FINAL NOTICE

DATE: November 18, 2020
TO: Blue Bird Owners
Subject: Recall R20AO, FMVSS 105 Noncompliance – Hydraulic Brake Units W/Floor Mounted Park Brake Hand Lever Assembly

IMPORTANT SAFETY RECALL NOTICE
NHTSA Campaign Number: 20V-234 (School Bus)
NHTSA Campaign Number: 20V-235 (Non-School Bus)

R20AO Hydraulic Brake Floor Mounted Hand Lever Setting

Photo A

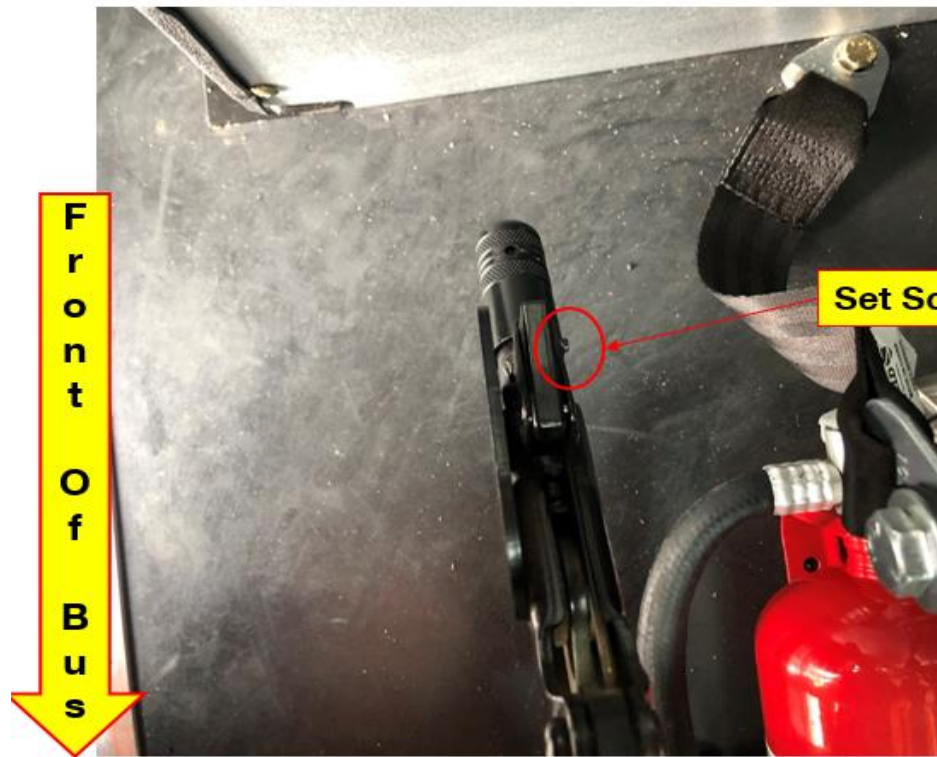
1. Place the park brake handle in the released position.
2. Attach a 16" rope tied into a loop if your force gauge is not equipped with a loop strap. (Reference Photo A)
3. Slowly pull up the hand lever to the peak park brake applied location. (Reference Photo B)
4. Pull several times to verify the setting.
5. If the force setting is 90 to 95 FT lbs. No other actions are required.

Photo B

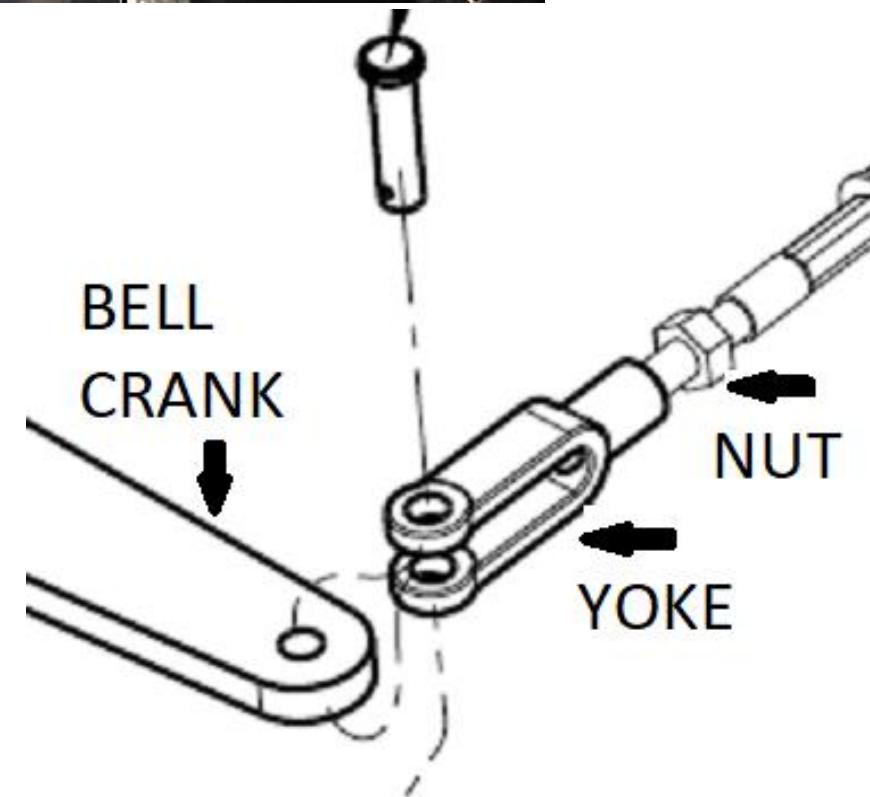
1. Use the instructions below to confirm the setting of the park brake handle, in the released position.
2. Attach the force gauge to slowly pull up the hand lever to the peak park brake applied location. (Reference Photo B)
3. It is important to keep the force gauge direction of pull at a 90-degree angle to the lever, as the lever rotates to the park brake applied location.
